Necessity and Timing of Supplemental Comments

We file these Supplemental Comments, together with Appendices, in FERC Docket RM12-22-000. We request that all these documents be a part of the Docket record, so as to assist the Commission and Commission Staff in rulemaking and any related FERC Order on GMD.

GIC Readings at Paradise TN on 1/24/2012

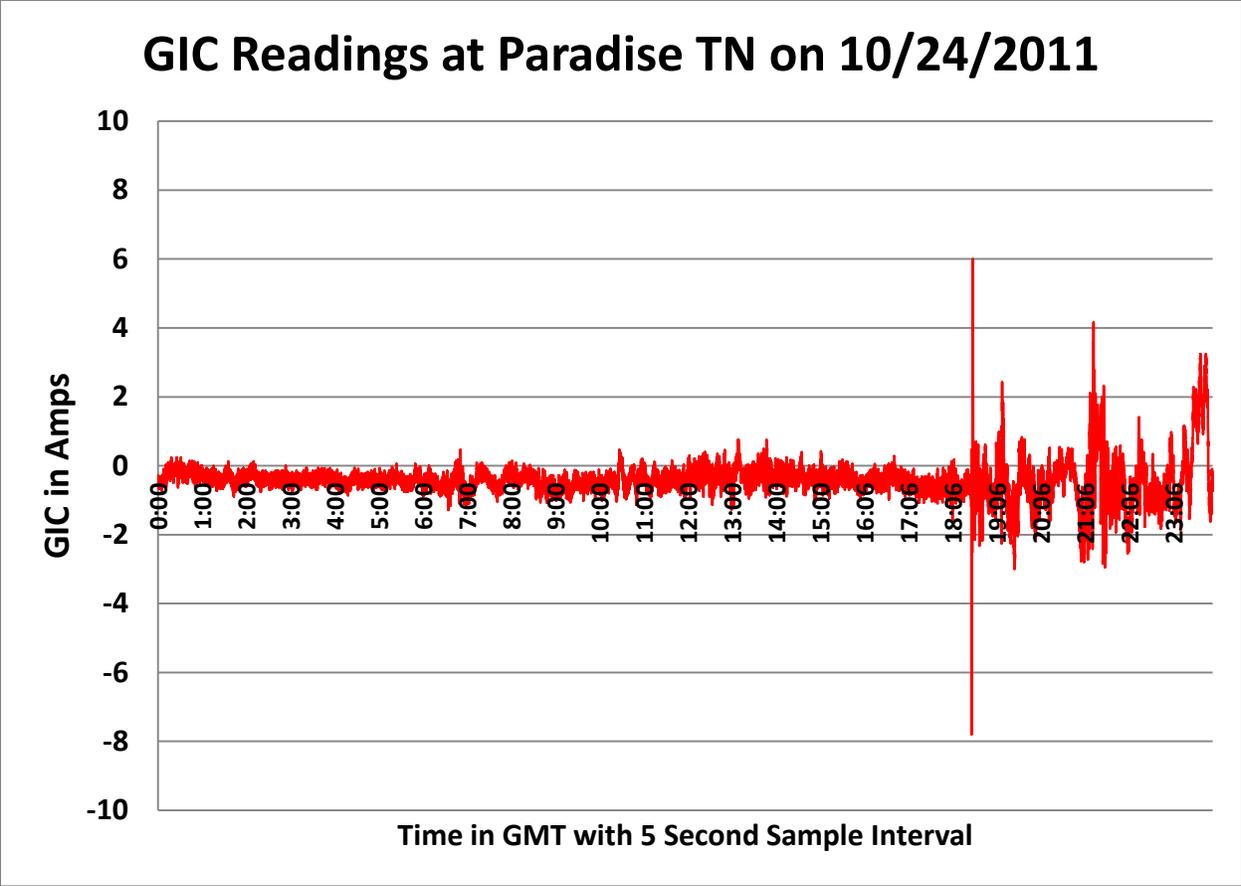
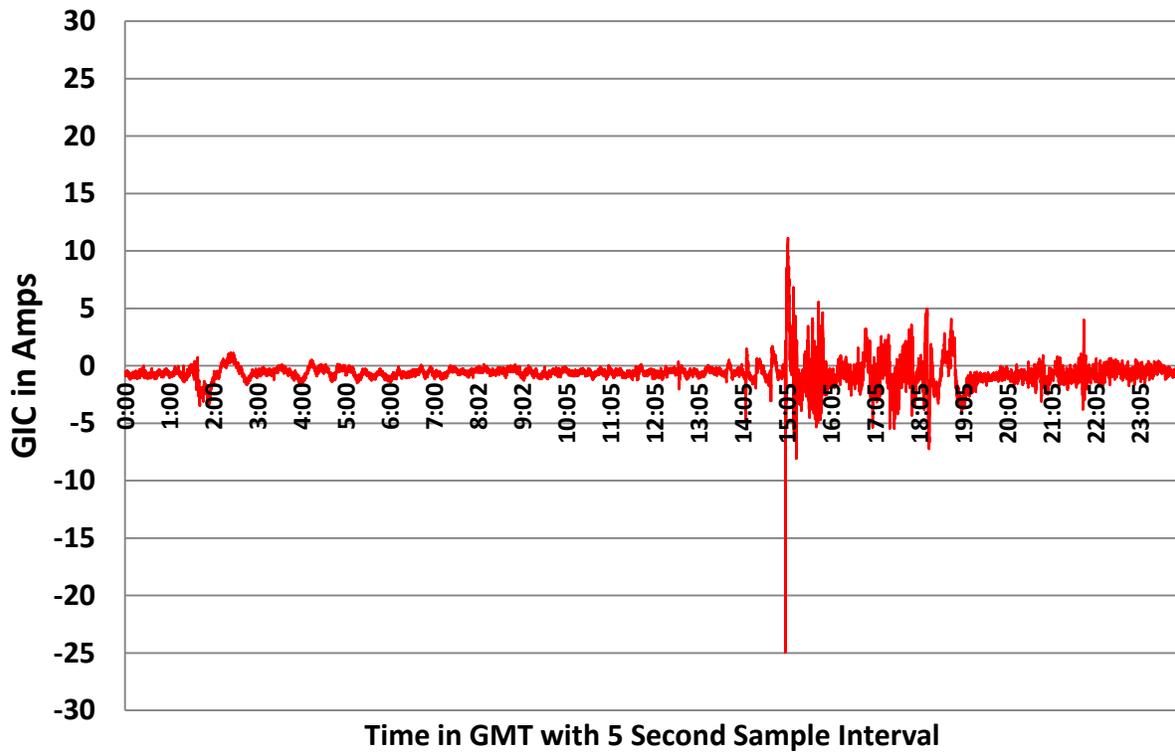
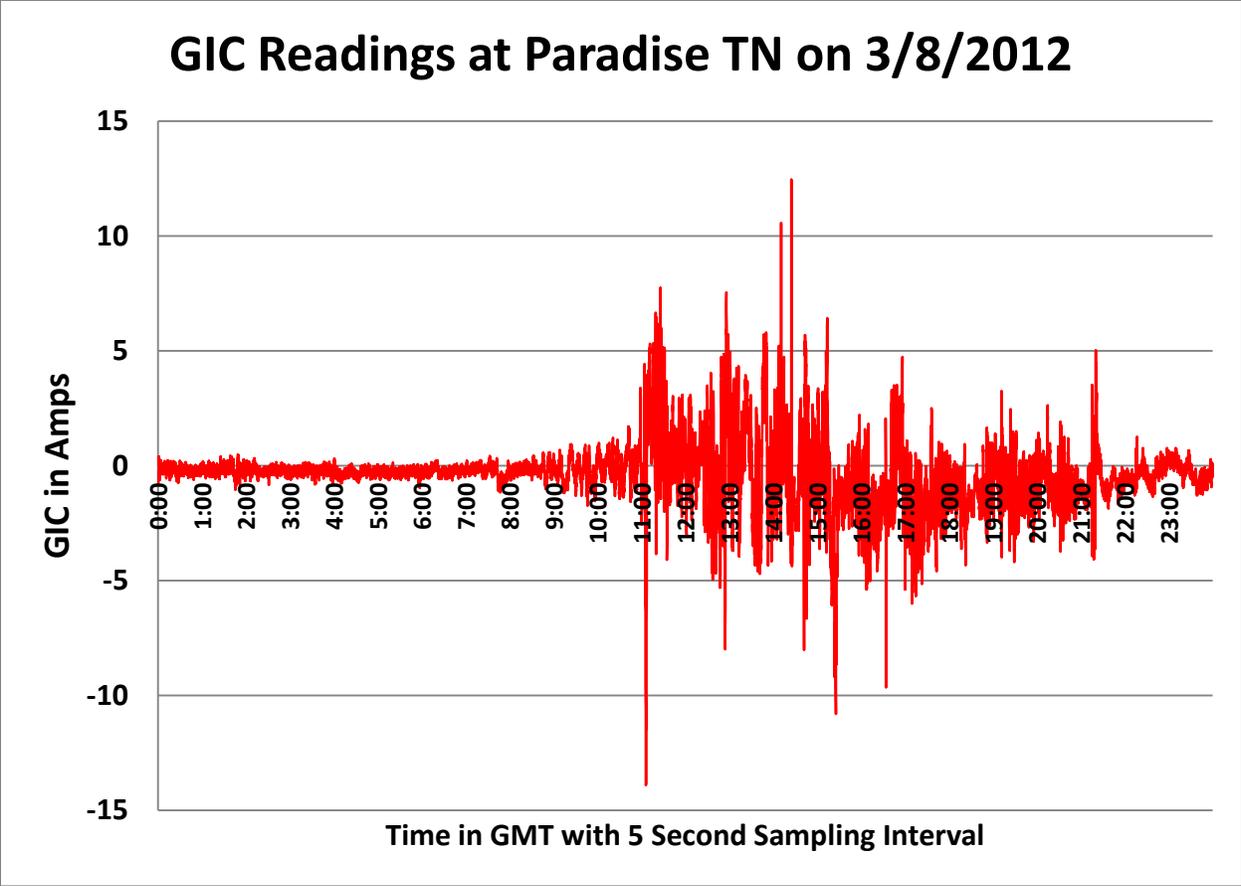
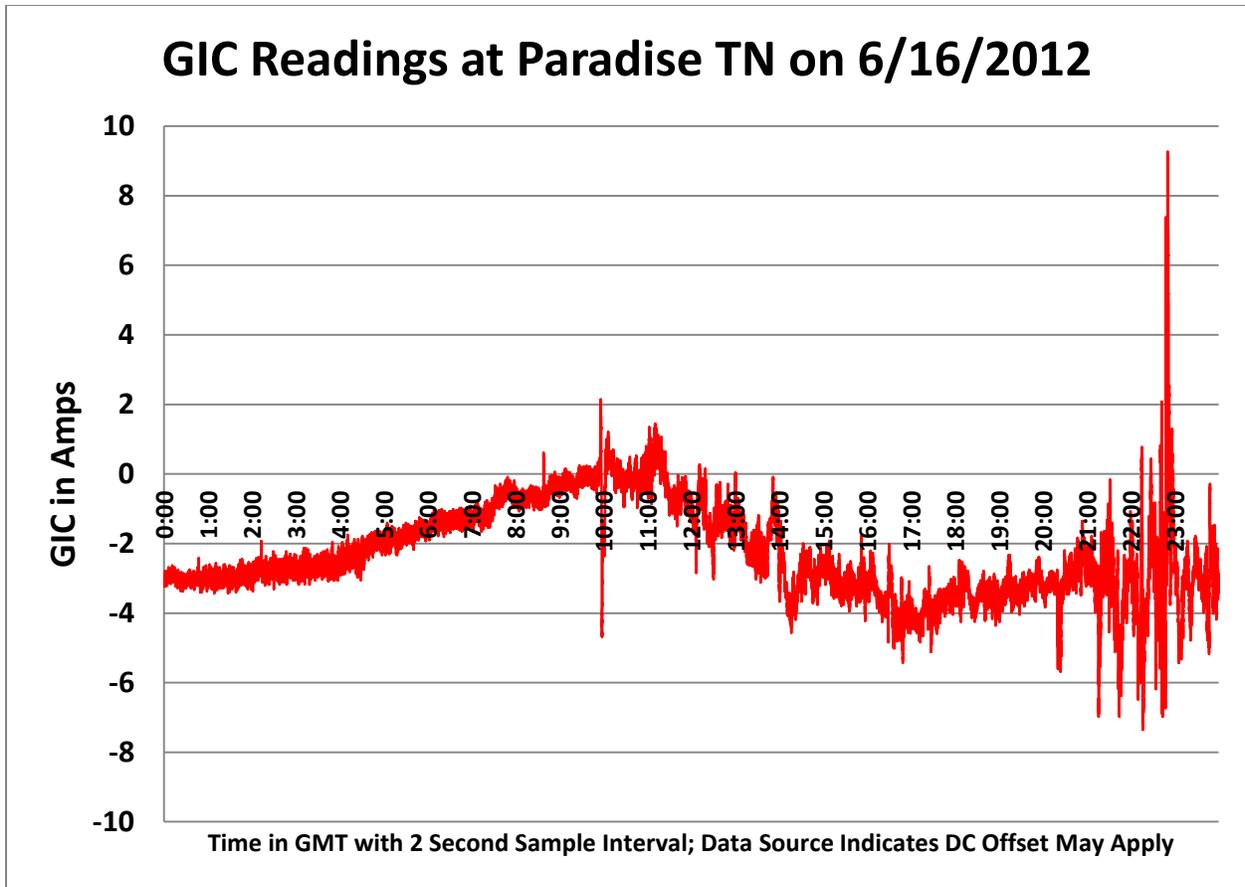
The September 26, 2011 solar storm commenced with a pulse shortly after 12:35 GMT. Absolute value GIC readings rose from 0.18 amps at 12:35:00 GMT to a peak of 17.64 amps in approximately 2 minutes.

The October 24, 2011 solar storm commenced with a pulse shortly after 18:31 GMT. Absolute value GIC readings rose from 0.76 amps at 18:31:00 GMT to a peak of 7.55 amps in less than 2 minutes.

The January 1, 2012 solar storm commenced with a pulse shortly after 15:03 GMT. Absolute value GIC readings rose from 0.55 amps at 15:03:00 GMT to a peak of 24.95 amps in 25 seconds.

The March 8, 2012 solar storm commenced with a pulse shortly after 11:03 GMT. Absolute value GIC readings rose from 0.73 amps at 11:03:00 GMT to a peak of 13.84 amps in less than 4 minutes.

In summary, for this sample of solar storms experienced at the Paradise site, GIC readings would not have given reasonable advance warning of sudden GIC spikes for four out of five storms.
